Our Ref: 17235

RE: 88 CHRISTIE ST, ST LEONARDS PROPOSED MIXED USE DEVELOPMENT RESPONSE TO SUBMISSIONS

As requested, The Transport Planning Partnership (TTPP) has prepared this letter in response to comments raised by Lane Cove Council and public submissions from the local community in relation to the above proposed development.

Figure 2: Photomontages of Proposed Signs

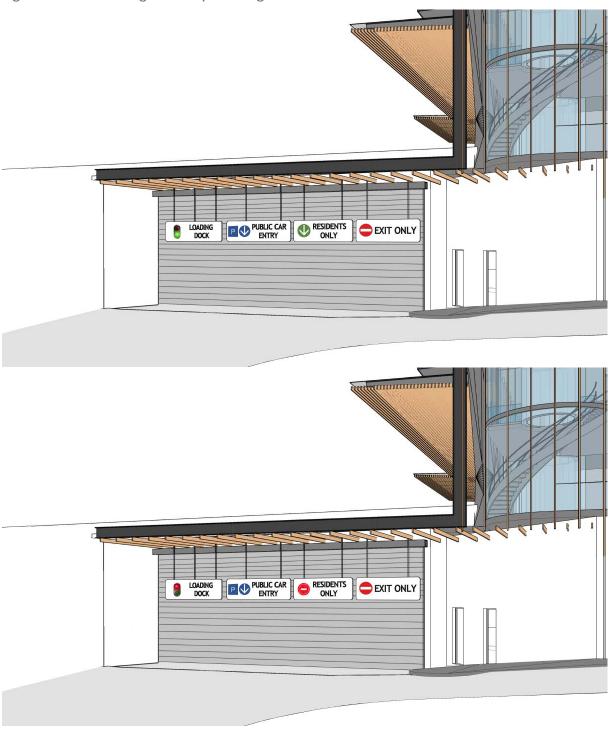
- 1. Adequate measures must be in place to ensure that public do not access the express access. The public may be unfamiliar with the proposed contra flow arrangement and given that it is a single lane ramp, there may be potential for head-on collisions. The plans indicating the proposed measures are required to be submitted to Council for approval.

- 2. Further details are required on the management of the contra flow operation.
- 3. Further information is required regarding the operation of the boom gates.

In relation to Item 1 above, signage will be installed across the driveway lanes and inside the basement level (Level B6) to manage the traffic flows using the express access ramp and the access to/from the public car park. The proposed signage is contained in Attachment One of this letter.

The public will not be permitted to use the express access ramp. The express access ramp will have a sign above it indicating that it is a residents only access.

The express access ramp/driveway will have appropriate variable message signs (VMS) as detailed in Attachment One to manage the contra flow. During the morning period when the express access would operate to permit egress movement, the VMS for the express ramp located at the street level would display a "RESIDENTS EXIT ONLY" with a no entry sign while at the other end of the express ramp inside the basement the VMS would display a "EXPRESS EXIT" sign indicating it as an exit only – see Figure 1 below.

Figure 2 shows photomontages what the signs would like from the view point of a driver on the new laneway.

Loading Dock Proposed Signs

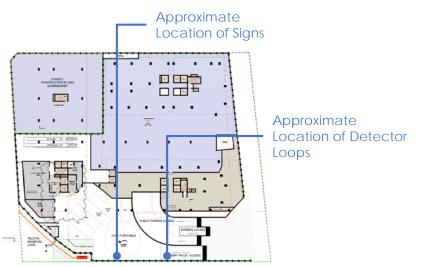
- 4. The delivery truck access is not accepted as a single lane. A two way road width must be maintained in accordance with AS2890.2 to ensure safe movement of delivery trucks.

Notwithstanding this, it is proposed to provide green and red traffic lights together with signage and line marking as detailed in Attachment One to manage the use of the driveway in a safe and efficient manner.

Traffic lights always default to red for vehicles inside the loading dock. Traffic lights switch to green when a driver activates a push button to request for a change of the lights.

Note: In addition to the signs, directional detector loops/sensors will be required at the locations shown to detect the passage of vehicles so that the traffic signal displays could revert back to default display i.e. green for entering vehicles and red for trucks inside the loading dock. In addition, push buttons will be located at strategic locations throughout the loading dock to allow truck drivers to make a request for the traffic signals inside the loading dock to change to a green display and the one on street level to change to a red display.

VEHICLE TURN PATH
PLAN
SHEET 1

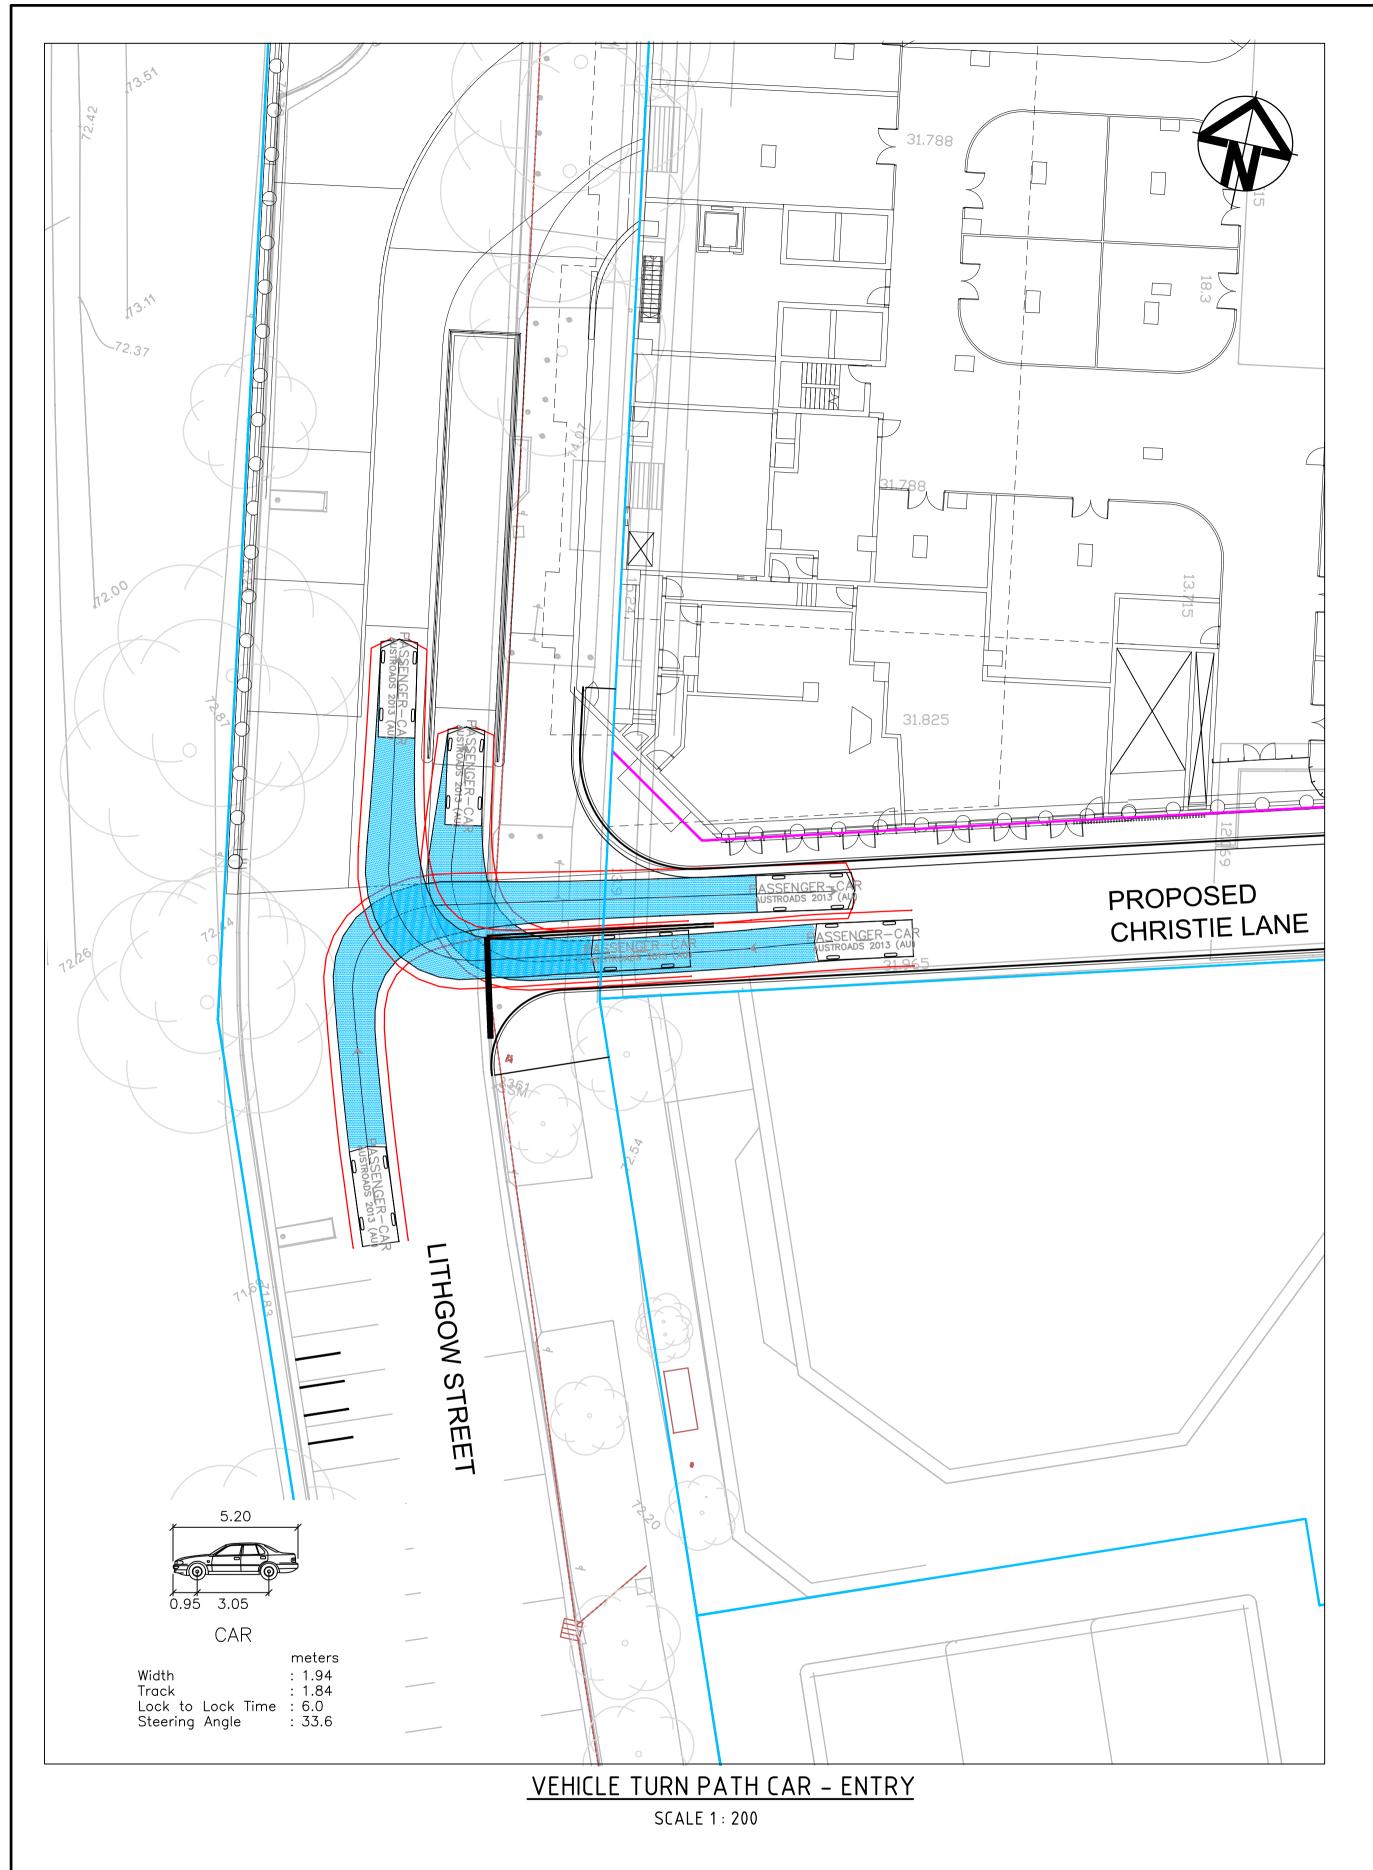
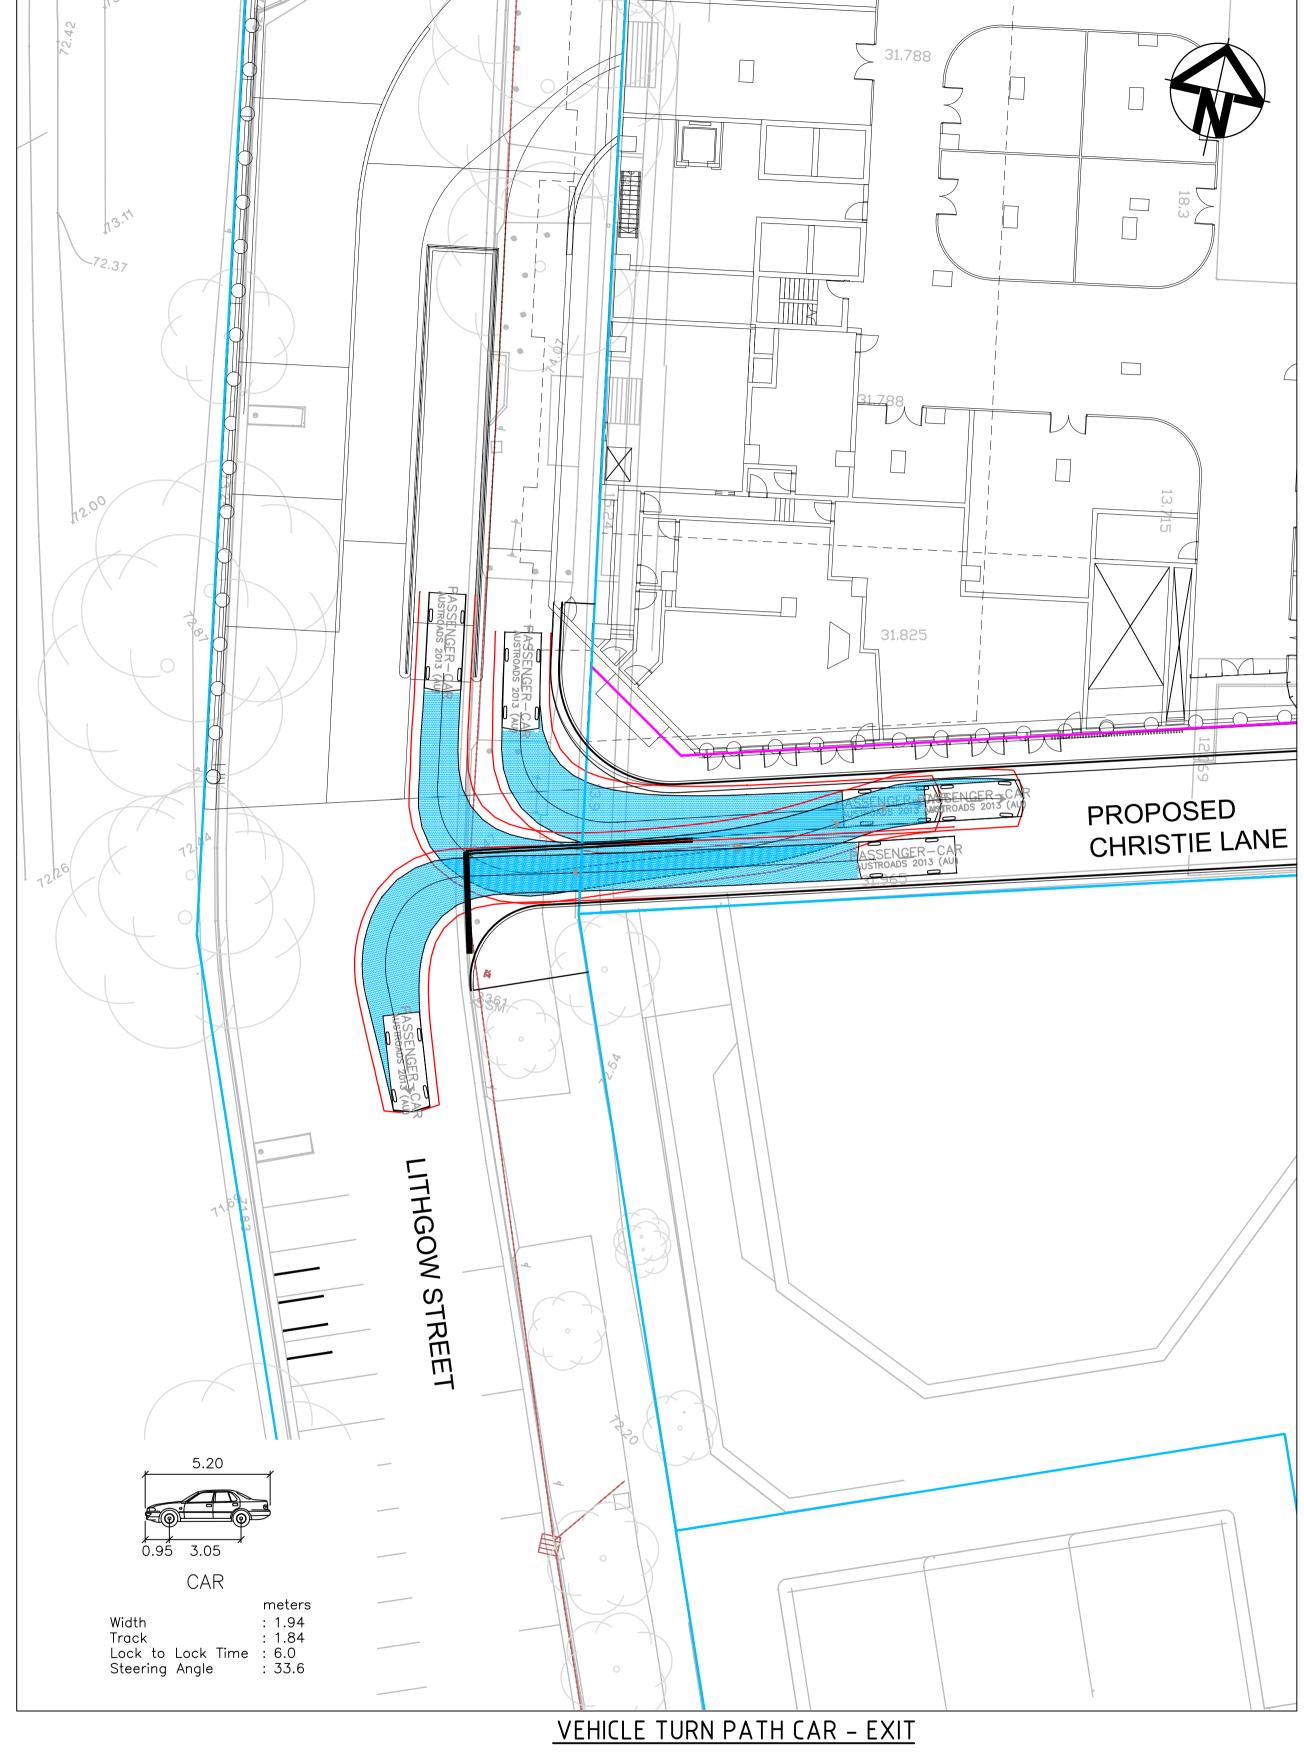
- 5. Swept paths demonstrating the turning movements for HRVs entering/exiting the site from the new Christie Lane is required. All swept paths to be done on a 6 metre carriageway (see points 14 and 15).

In relation to Item 5, swept path analysis was carried out by consultant AT&L as part of their civil engineering documentation accompanying the development application. These swept path diagrams are provided in Attachment Two.

AT&L confirms that the design of the laneway and relevant section of Lithgow Street has been designed in accordance with requirements set out in Austroads Guide to Road Design. There would be sufficient sight distance to allow vehicles to self manage themselves as they pass each other turning around the corner.
